SERVICE INFORMATION NO. SI 20-080

Rotax Service Bulletin No. SB-912-070R1 Inspection and/or replacement of the valve push-rod assy

SERVICE BULLETIN

Inspection and/or replacement of the valve push-rod assy., rocker arm left and rocker arm right for ROTAX® Engine Type 912 i, 912 and 914 (Series)

Fig. 1
Visual inspection

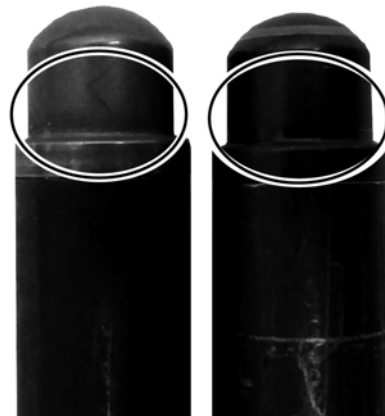
Perform visual inspection of all push-rod ball sockets on all cylinder.
 Check for color. See Fig. 1.

Color	Evaluation
Silver surface	Valve push-rod is OK. No further action required for this valve push-rod.
Black surface	Valve push-rod is NOT OK. See section. 3.1.3) Replacement of affected parts.

Fig. 2

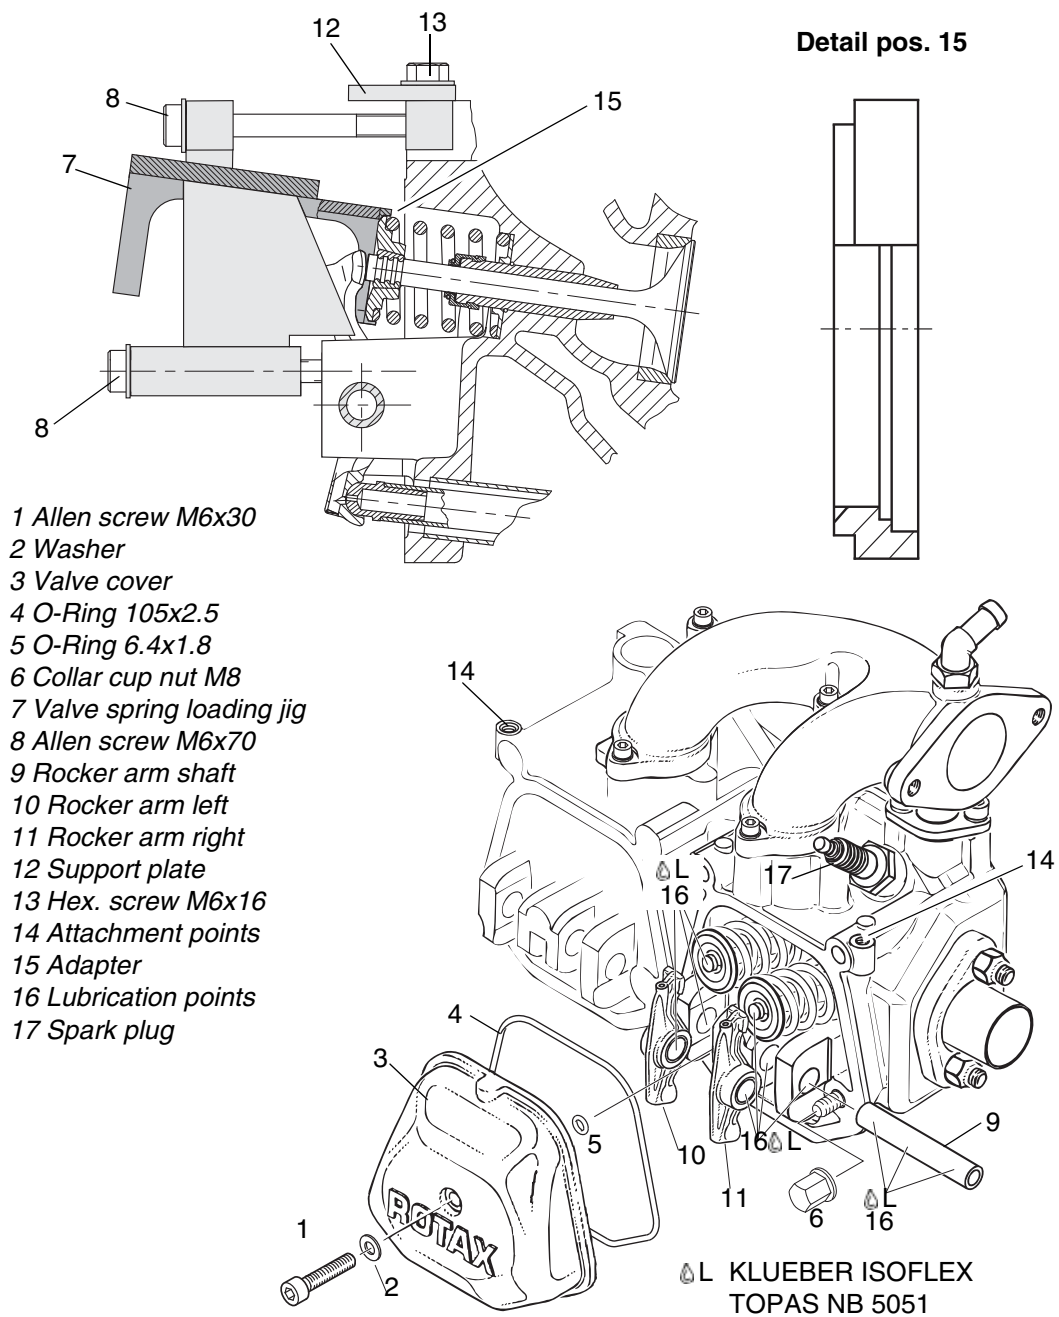
See Fig. 2.

Step	Procedure
1	Loosen Allen screw (1) M6x30 with washer (2) from valve cover (3), and remove it together with large and small O-rings (4) and (5).

Step	Procedure
3	Attach the support plate (12) to the valve spring loading jig part no. 877387 (7) with 2 hex. screws (13) M6x16 at the attachment points (14) on the cylinder heads.
4	Put adapters (15) on the valve spring loading jig.
5	Attach the valve spring loading jig on cylinder head and support plate with 2 Allen screws (8) M6x70 and depress both valves with 3 turns.

Step	Procedure
1	Clean the sealing surface of cylinder head and valve cover with a suitable lint-free cloth or equivalent.
2	Insert new O-ring (4) 105x2.5 and O-ring (5) 6.4x1.8 into the valve cover (3).
3	Fit valve cover.

Step	Procedure
4	Tighten the new Allen screw (1) M6x30 with washer (2) to 10 Nm (89 in.lb).

Fig. 3

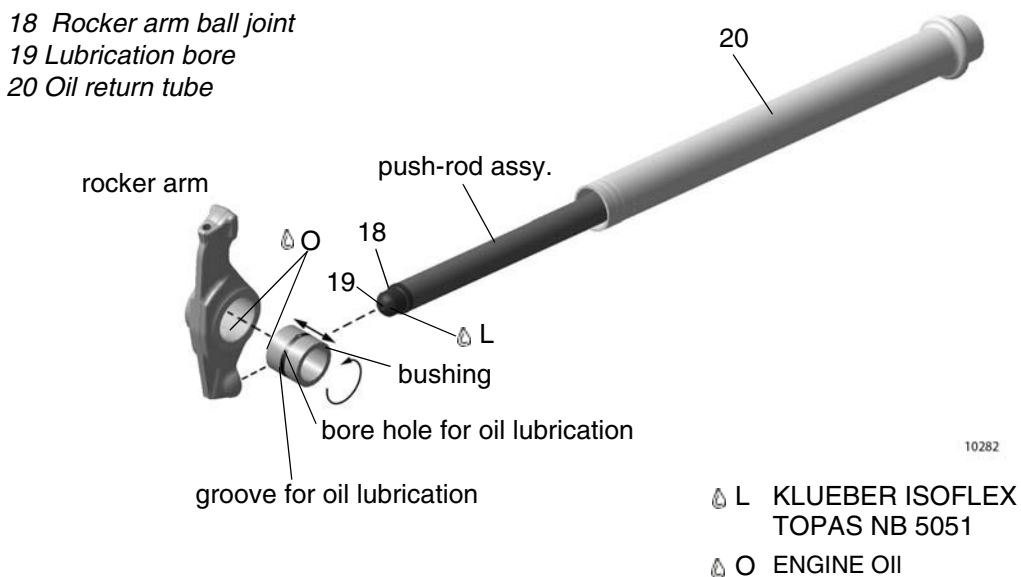
See [Fig. 2](#) and [Fig. 3](#).

On valve trains with valve push-rods found NOT OK the following steps need to be performed:

Step	Procedure
6	This will relieve the pressure from both hydraulic tappets. Now the rocker arm shaft (9) may be easily pulled out. Lift out both rocker arms (10) and (11).
7	Replace only affected parts as per section 2.3 . See also Fig. 3 .
8	Apply KLÜBER ISOFLEX TOPAS NB 5051 (16) on both push-rod ball sockets and contact areas of rocker arm and slide push-rod into the oil return tube (20).
9	Check bushing and rocker arm shaft according to latest Maintenance Manual Heavy.
10	Put oil on the rocker arm bushing.
11	Place rocker arm left (10) and rocker arm right (11) in cylinder head, apply KLÜBER ISOFLEX TOPAS NB 5051 (16) on rocker arm shaft (9) and insert it into its bearing support.
12	Loosen valve spring loading jig and support plate.
13	When removing the valve spring loading jig, make sure the adapter rings (15) do not jam on the valve spring retainer.
14	NOTE: Only when you have an Criterion B) Spare parts affected engine and only if engine is equipped with collar cap nuts M8 wrench size 13: Mount collar cap nut (6) according to latest Maintenance Manual Heavy or SI-912-025/SI-914-026/SI-912 i-010.
